# Application for change or cancellation of resource consent condition (S.127)

This application relates to the following resource consent: **RC2230414-RMALUC**

**RE: RC 2230414-RMALUC - Proposed Minor Variation to plans and impermeable surface, at 45 Riverview Road, Kerikeri – Warren Fraser**

# APPLICATION FOR A CHANGE OF CONSENT CONDITIONS TO RC 2230414-RMALUC PURSUANT TO s127 OF RMA

1 Proposed Ground Floor Plan 1:50

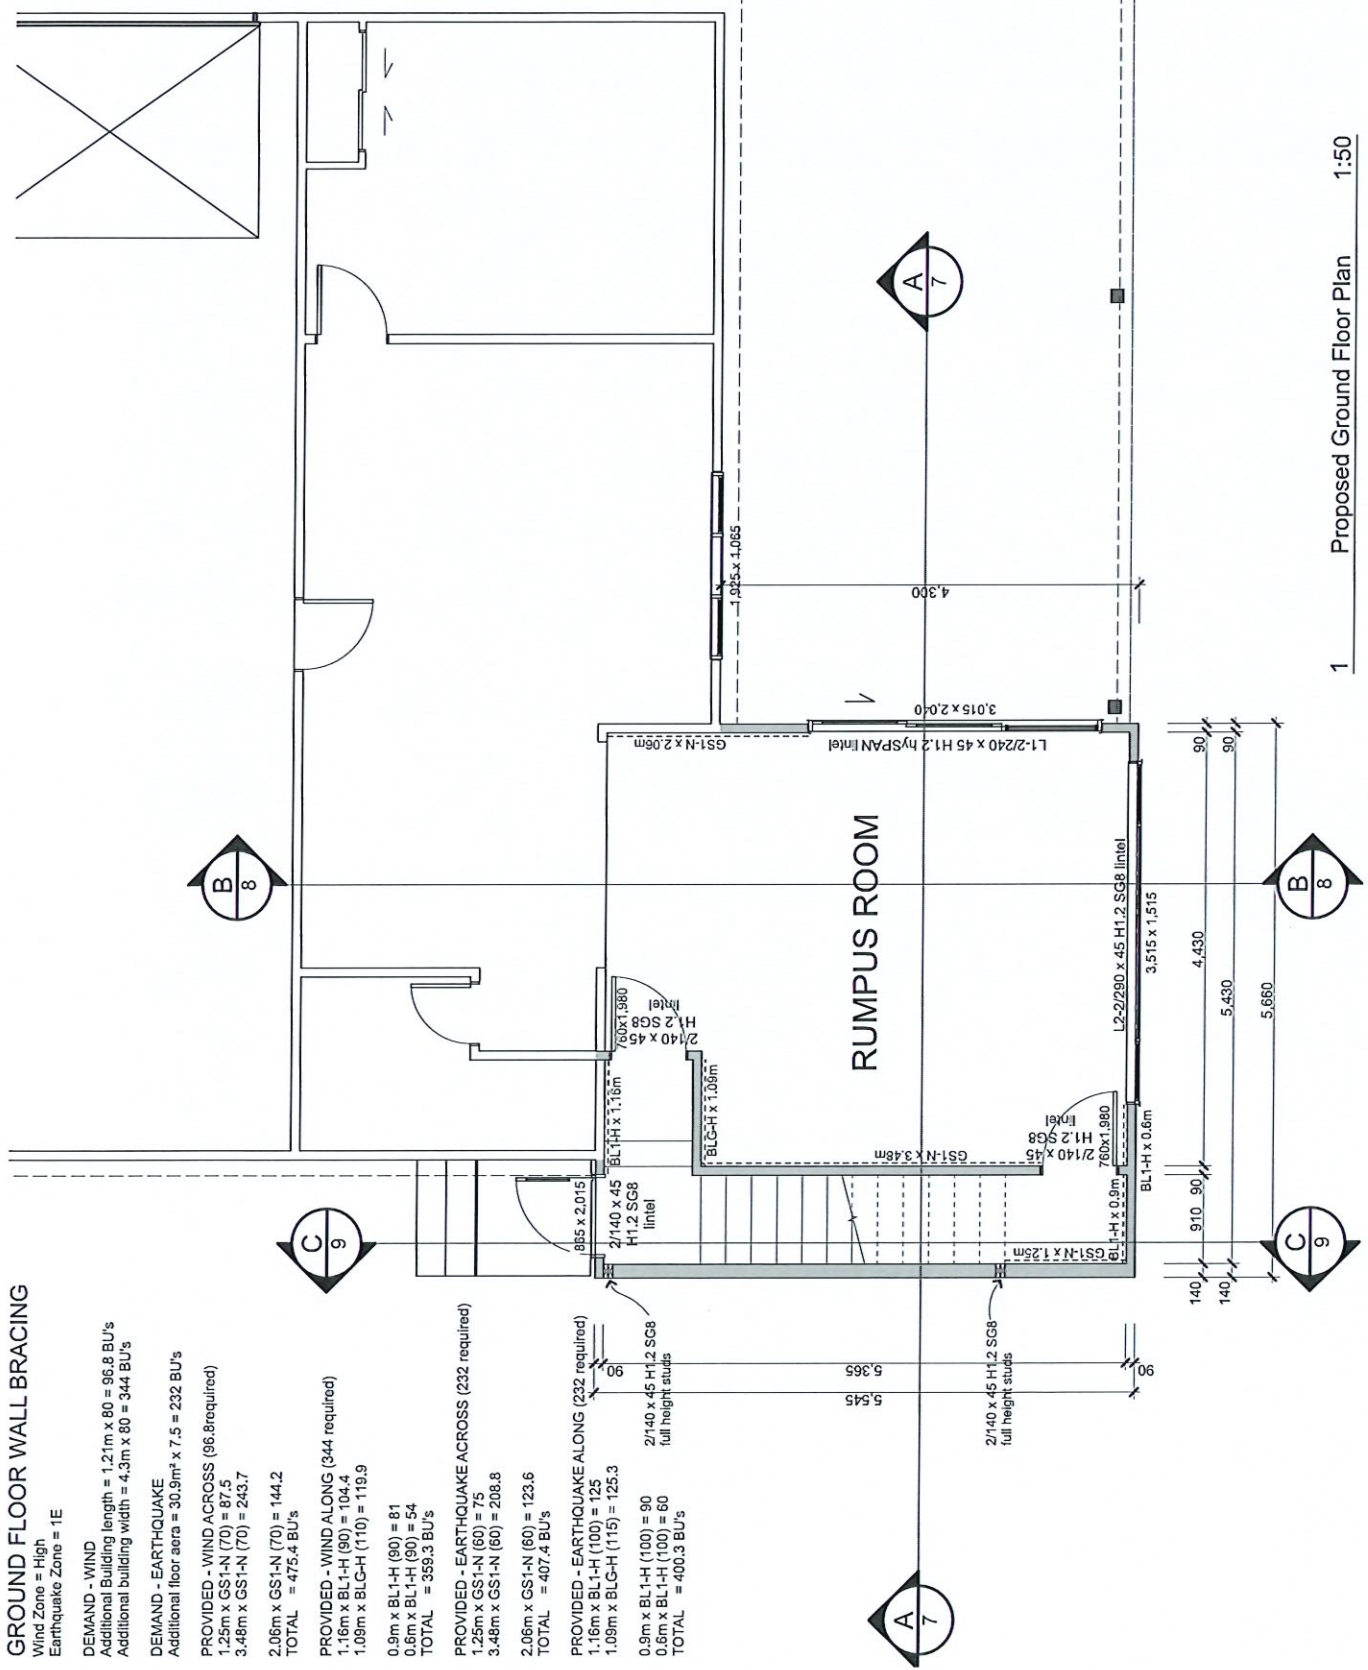
Condition 1 updated to reflect updated plans for amended building consent;  
Condition 2 updated to reflect updated Stormwater Management Report for same.

1. The activity shall be carried out in general accordance with the approved plans prepared by ~~Permit Shop~~ Total Design Building and Landscape Design, referenced Proposed Additions and Alterations to Existing Dwelling House dated 21.09.2023 01.07.2025 and attached to this consent with the Council's "Approved Stamp" affixed to them:
  - ~~Existing and Proposed Site Plan, Sheet 1.2~~
  - ~~Roof Plan – Level 1, sheet 1.9~~
  - ~~North Elevations, sheet 2.1~~
  - ~~South Elevations, sheet 2.2~~
  - ~~West Elevations, sheet 2.3~~
  - ~~East Elevations, sheet 2.4~~
  - Site Plan, Drawing No 1;
  - Proposed Ground Floor Plan, Drawing No 2;
  - Proposed First Floor Plan, Drawing No 3;
  - Elevations, Drawing No 4;
  - West Elevation, Foundation Plan, Drawing No 5.

PROPOSED ALTERATION  
STORMWATER PLAN

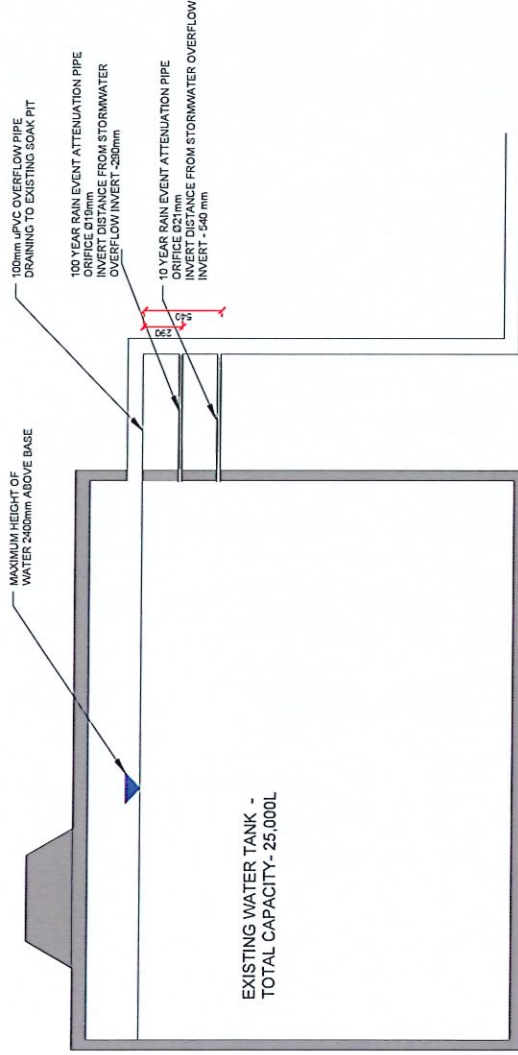
*Within three months of completion of the renovation work, the stormwater system shall be constructed in general accordance with the Stormwater Management Report by PK Engineering (reference 21—085, dated February 2023, and amended REV 2 July 2025). The soakage pit is required to be kept clear and maintained on an ongoing basis to ensure full efficiency.*

The above minor change reflects the update to the Stormwater Management report.

Job No: 21-085  
Date: December 2022  
Amended February 2023  
Amended REV 2 July 2025 Attenuation calcs and report amended to reflect additional  
impermeable surfaces as per Total Design Plans 1/07/2025
